CITY OF DONNELLY PLANNING & ZONING COMMISSION'S

City of Donnelly Planning and Zoning Commission Administrator Staff Report

Moudy Retail/Storage 236 N Main St.

Application: Design Review

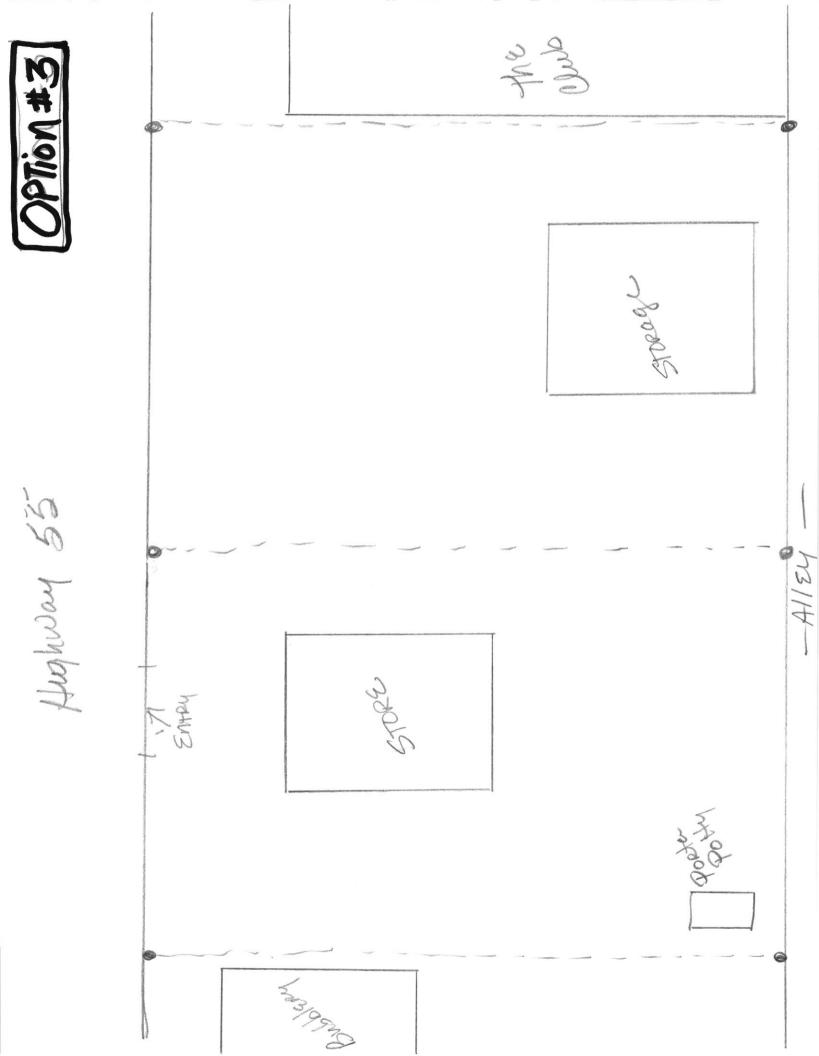
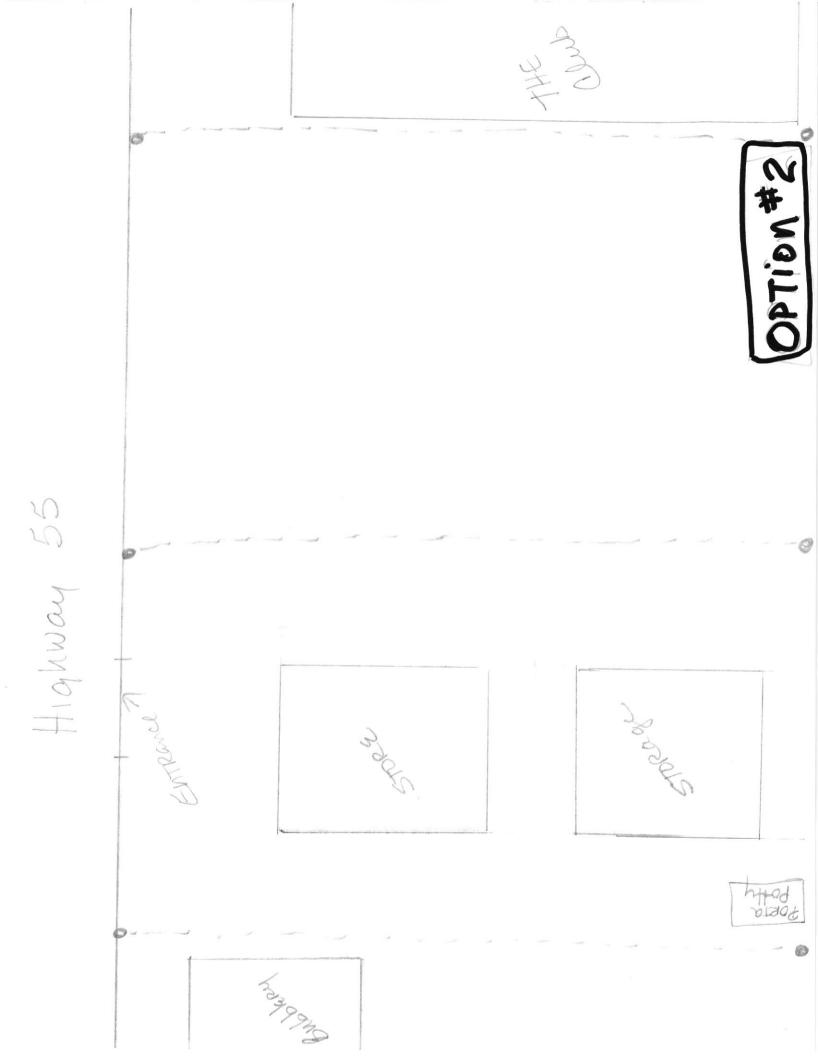
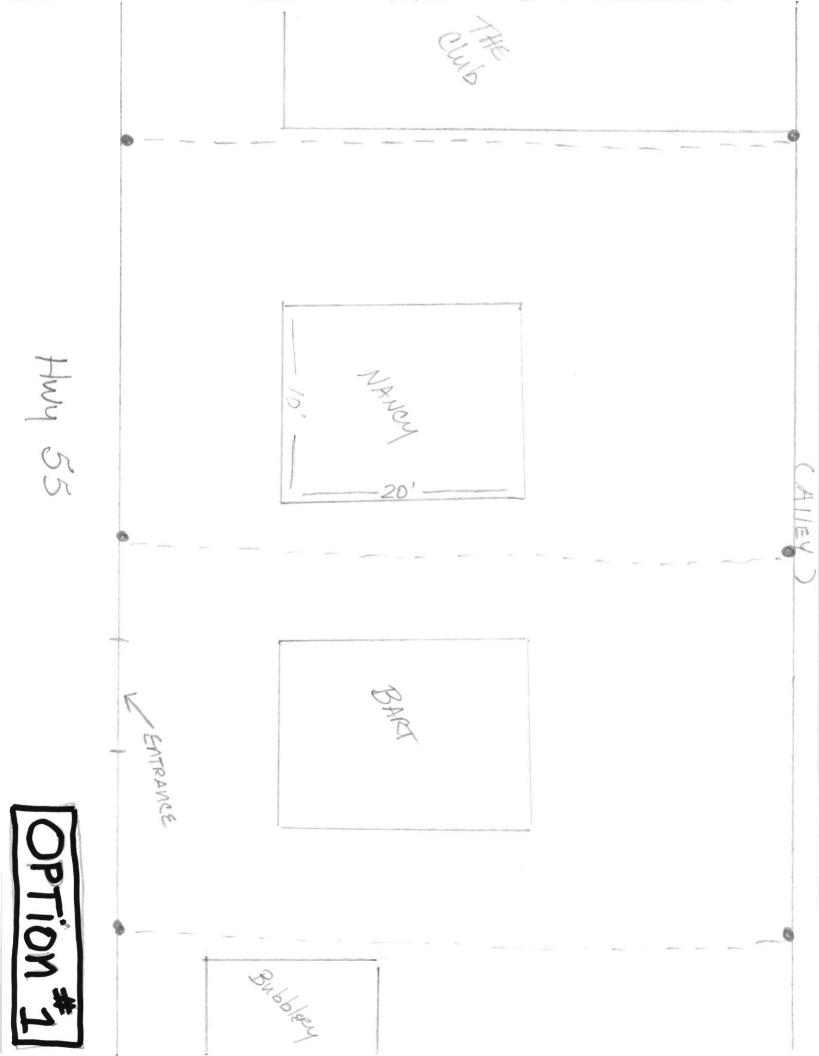
- Option 1: Shed is placed on the adjacent parcel to the north and a false storefront is constructed to connect the existing structure to the new shed. This option creates a new commercial structure on a parcel that does not currently have a structure on it. This raises the question as to whether DCC 13.05.010 applies, which states, "*All premises for which a building permit is issued for new residential, commercial or industrial use shall be and are hereby required to connect to the Donnelly city water system at the then-current connection fees established by the city.*" Commercial structures, regardless of size, are required to obtain a building permit.

- Option 2: The shed is placed on the same parcel and behind the existing structure. In this option, the proposed structure would be considered an accessory storage building (DCC 18.60.040) associated with the existing use of the parcel. No requirement to connect to central water would apply. Accessory structures are required to be placed to the rear of the primary use (DCC 18.60.050.M).

- Option 3: Place the shed to the rear of the northerly parcel. This option creates a new commercial structure on a parcel that does not currently have a structure on it. This raises the question as to whether DCC 13.05.010 applies, which states, "*All premises for which a building permit is issued for new residential, commercial or industrial use shall be and are hereby required to connect to the Donnelly city water system at the then-current connection fees established by the city.*" Commercial structures, regardless of size, are required to obtain a building permit.

1. The applicant has not submitted a complete Design Review application in accordance with the application requirements of Donnelly City Code (DCC 18.135). The submittal lacks a site plan drawn

- a. Maximum building height: The submitted plans do not indicate the building height.
- b. Front setback: No setback dimensions are indicated, however the submitted site plans illustrate that all of the placement options proposed will meet the minimum setback requirement of zero feet (0').

- 7. Fences and Signs (DCC 18.95):
 - a. Fences: The property is currently fenced. No new fences are proposed.
 - b. Signs: It is unclear if additional signage is proposed. A sign is shown on one of the submitted plans, however the narrative states that signage is Not Applicable (N/A).

- 1. Option 2 of the submittal is likely the best option for the applicant as it just adds an accessory structure to a parcel with an existing commercial use building and, therefore, would not trigger the extent of requirements of a new commercial use on an undeveloped lot.

- 2. Direct the applicant to choose <u>one</u> of the proposed options based upon the comments above and compete the Design Review application by providing the following as required by DCC 18.135.040:

- a. A plan of the proposed site, <u>drawn to scale</u>, showing the location of all buildings, parking and loading areas, snow storage areas, traffic access and circulation, open spaces, easements, existing and proposed grade, landscaping, exterior lighting, refuse and service areas, utilities, signs, and property.

- b. A separate plan showing <u>all exterior elevations</u> of the proposed structure or improvements to an existing structure.
